Updated layout

We have made changes to the proposed layout of Binn Solar and BESS Farm based on the feedback received at the first public exhibition and the results of environmental surveys.

NEW SITE LAYOUT

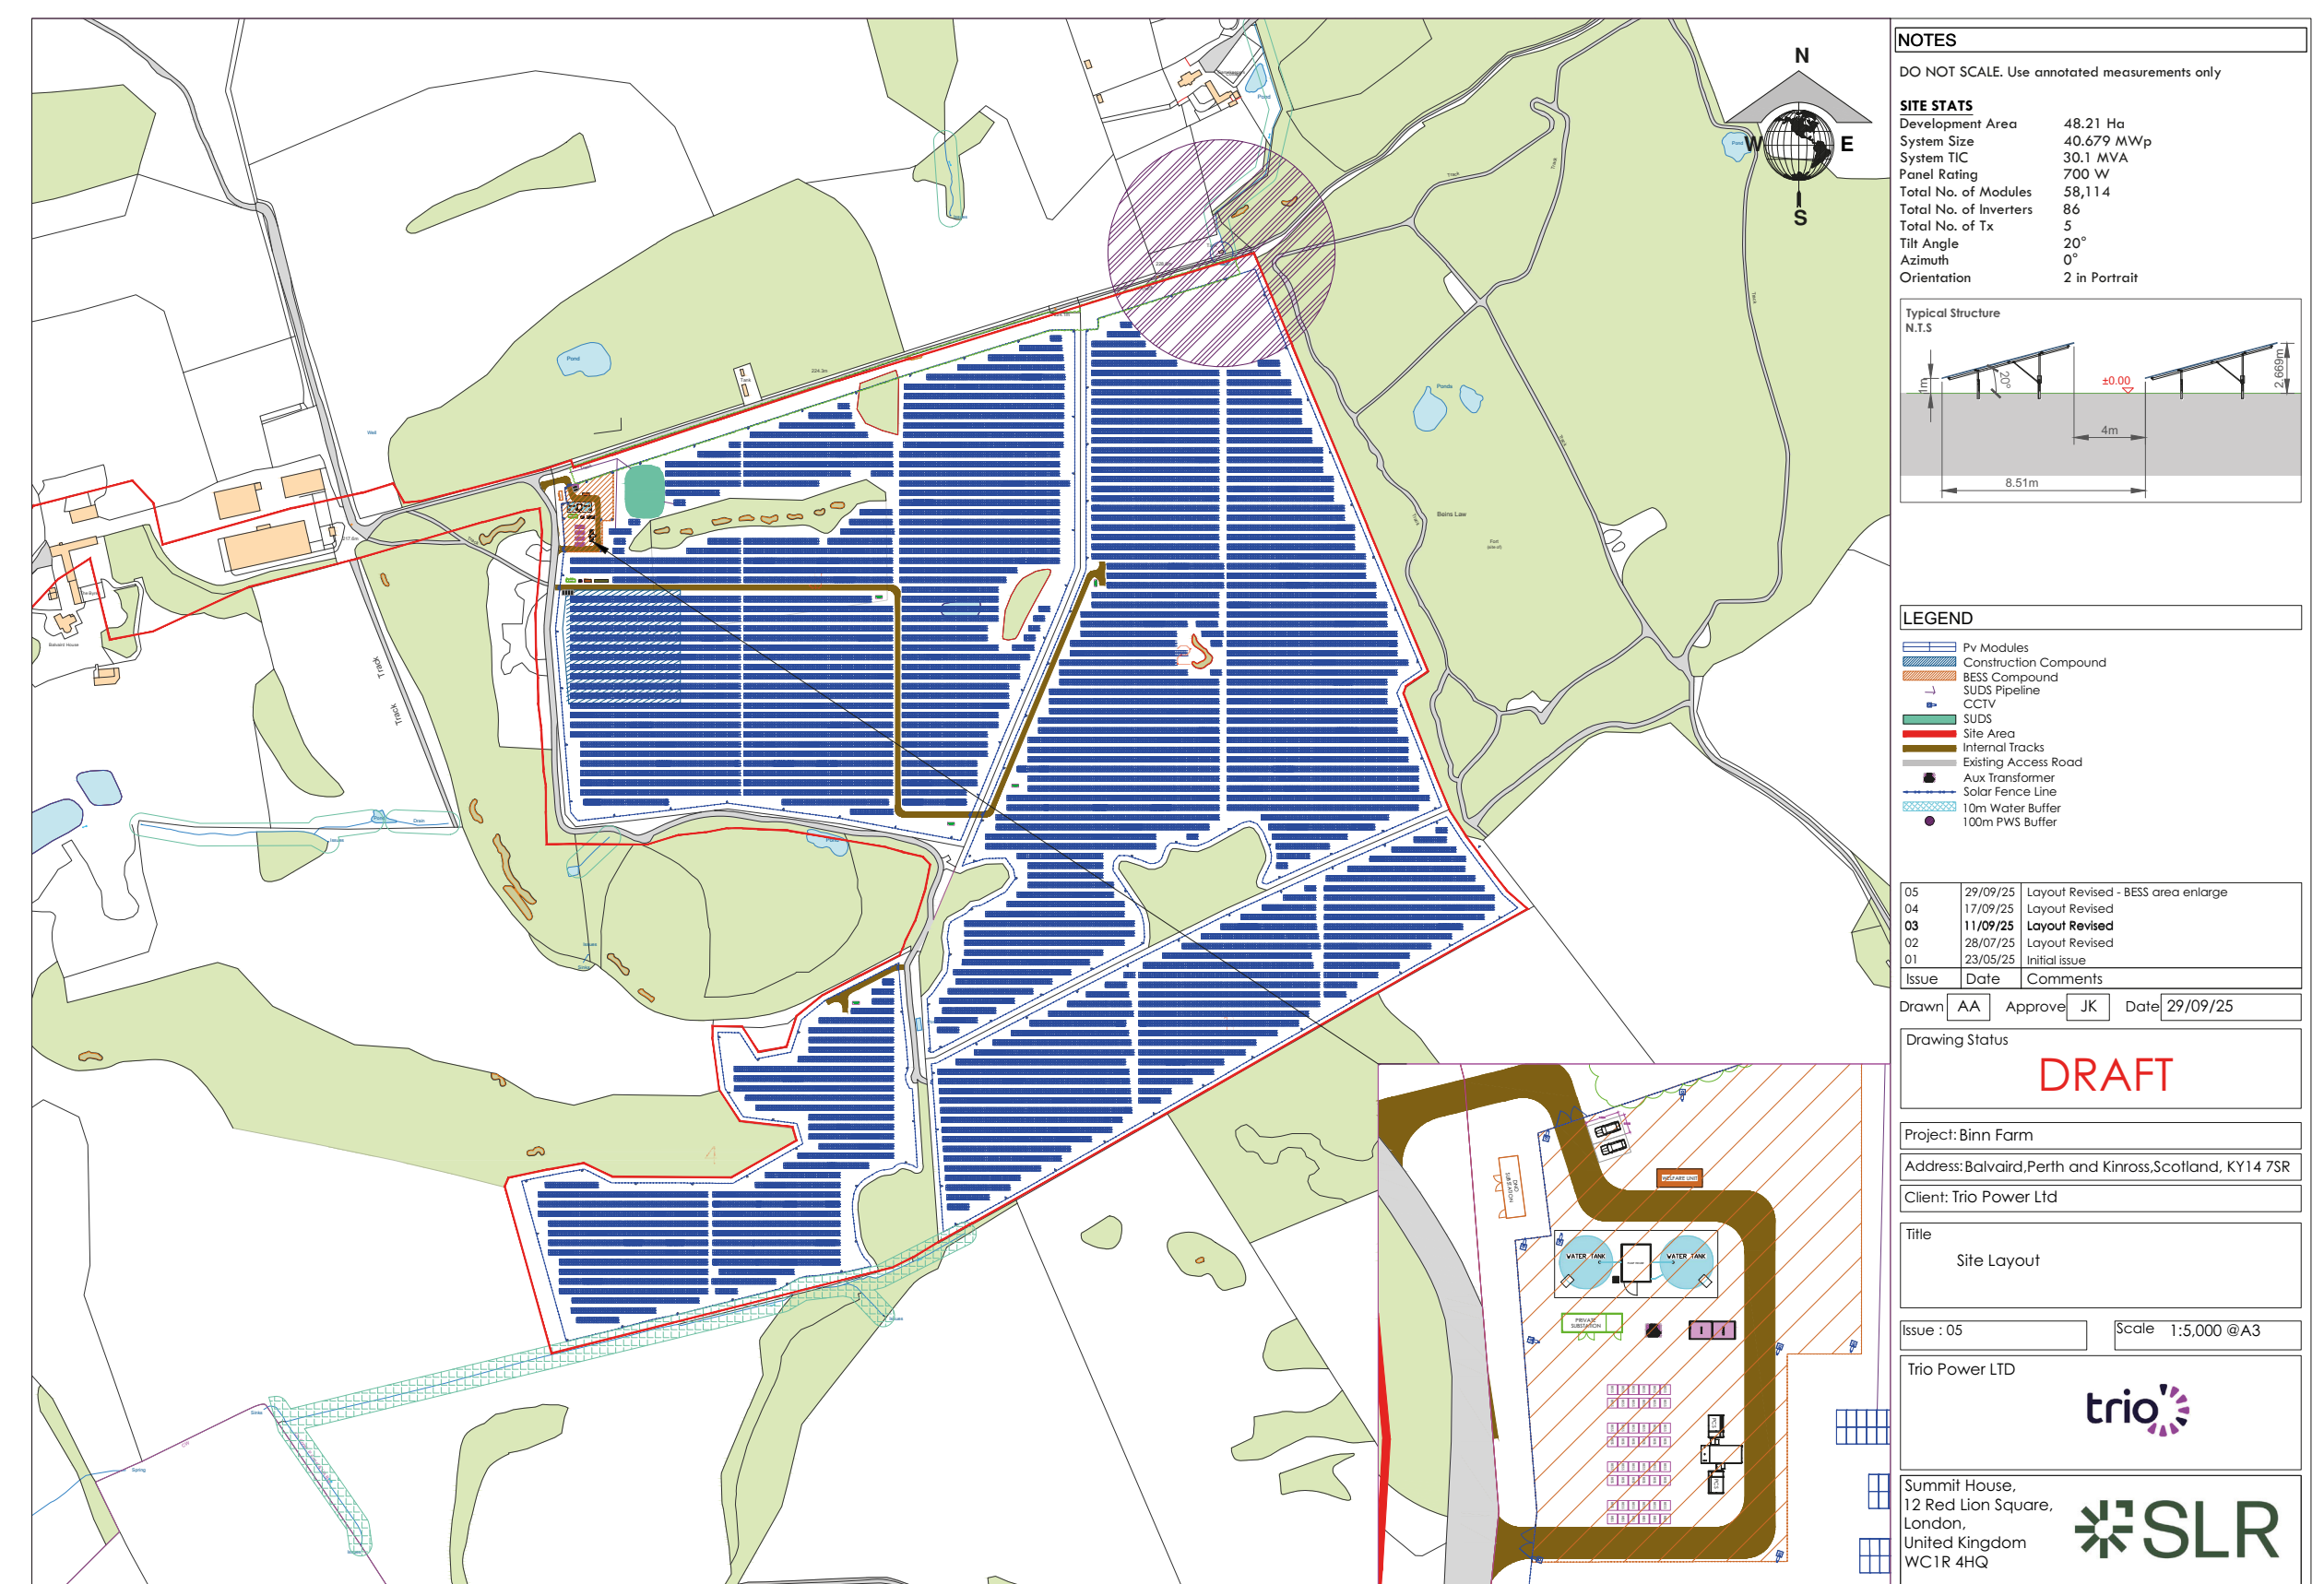
- Designed a 100m buffer around private water supplies in the north-east of the site.
- Ensured infrastructure is maintained outside watercourse buffers.
- Planned additional scrub planting in the south-west of the site to provide screening of views from Balvaird Castle.
- Planning additional screening in the south-east of the site to screen from the glamping pods to the east.
- Increased the buffer along the north of the site to allow for planting.
